## RIVERSIDE-CORONA FEEDER PROJECT

### FINAL SUPPLEMENTAL ENVIRONMENTAL IMPACT REPORT SCH No. 2003031121

**February 2012**

## **Section 2    Response to Comments**

FIGURE 4

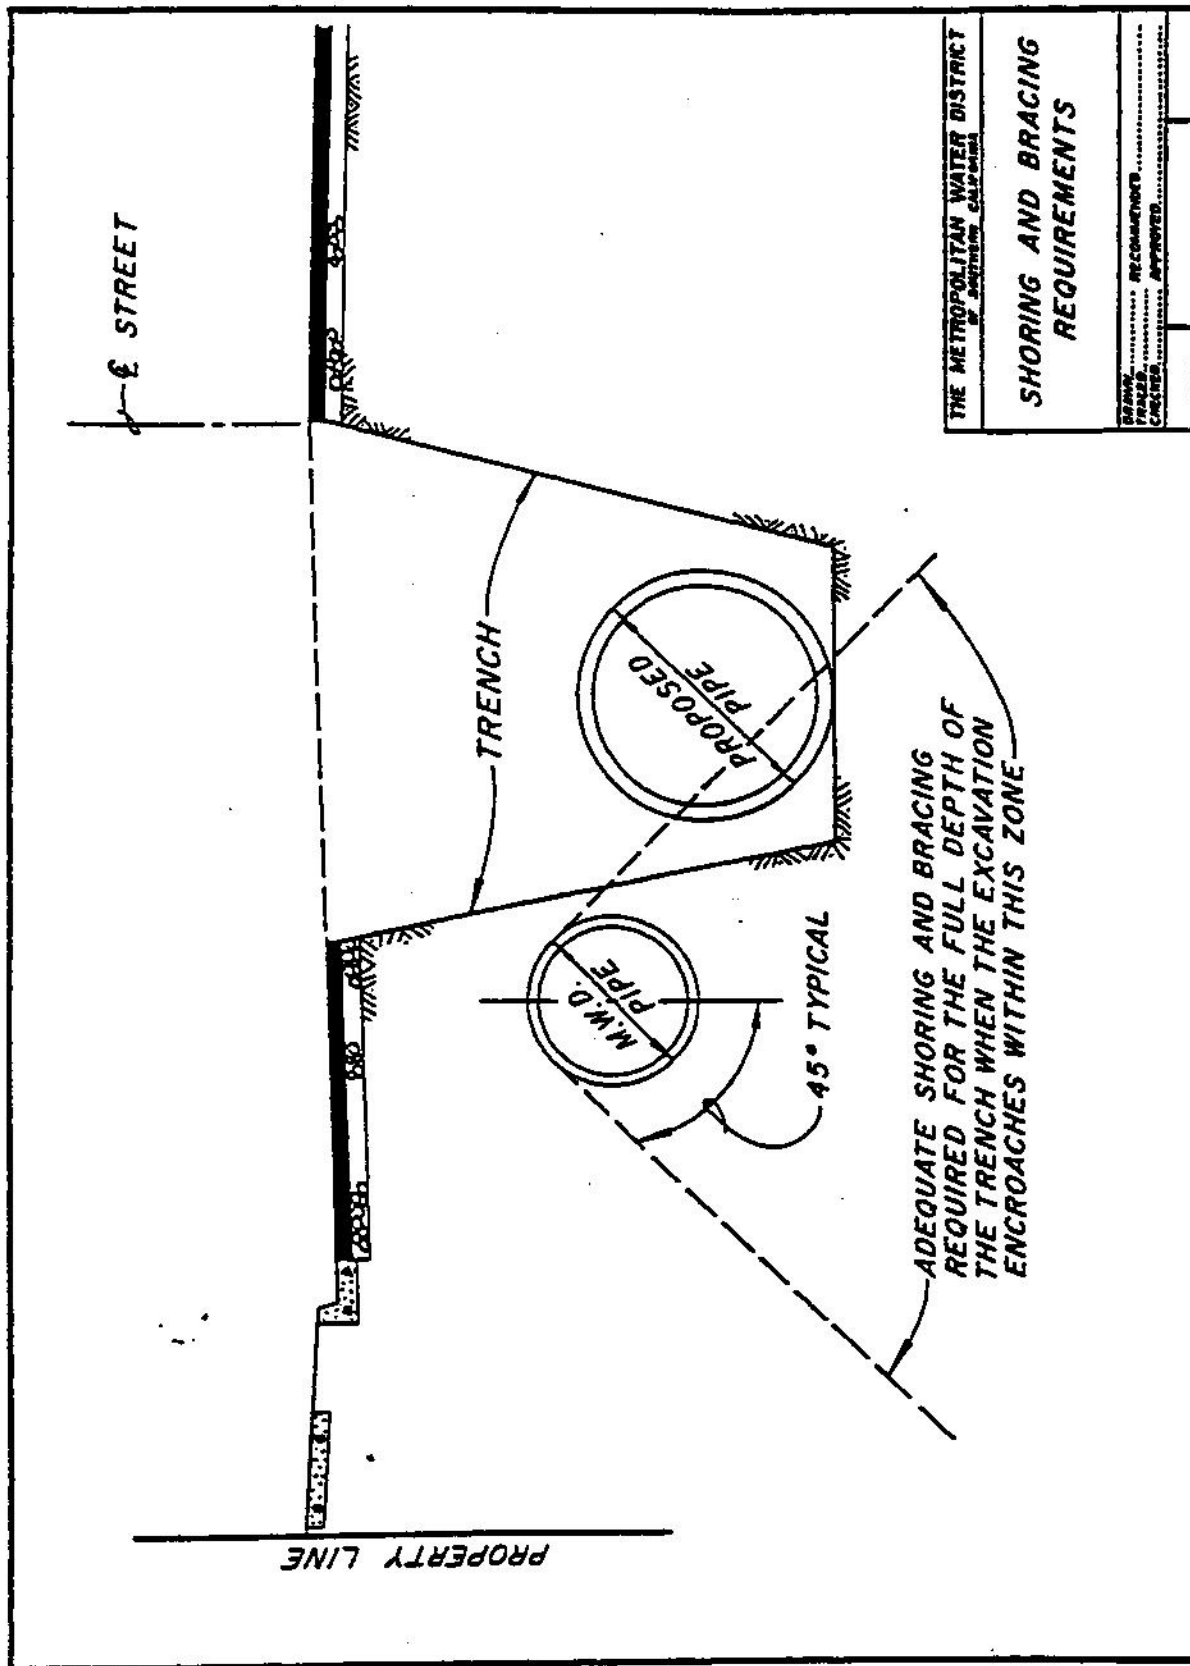
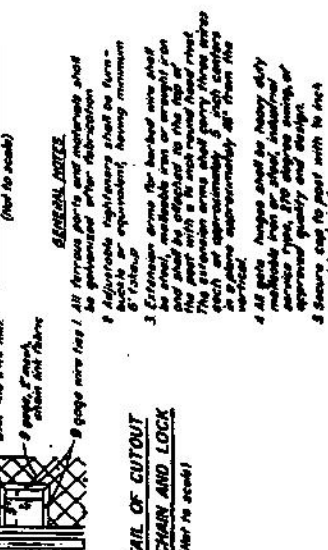
k. Adequate shoring and bracing is required for the full depth of the trench when the excavation encroaches within the zone shown on Figure 4.

**FIGURE 5**

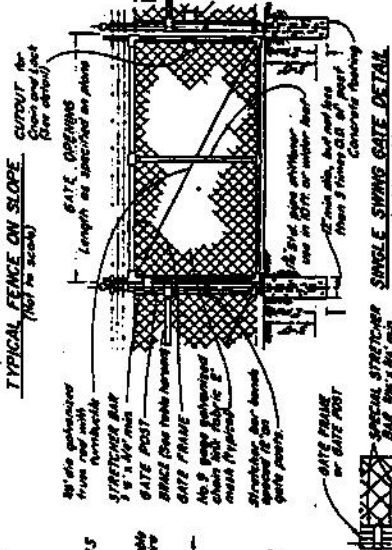
Metropolitan requires that perimeter fencing of its fee properties and facilities be constructed of universal chain link, 6 feet in height and topped with 3 strands of barbed wire angled upward and outward at a 45 degree angle or an approved equal for a total fence height of 7 feet. Suitable substitute fencing may be considered by Metropolitan. (Please see Figure 5 for details).
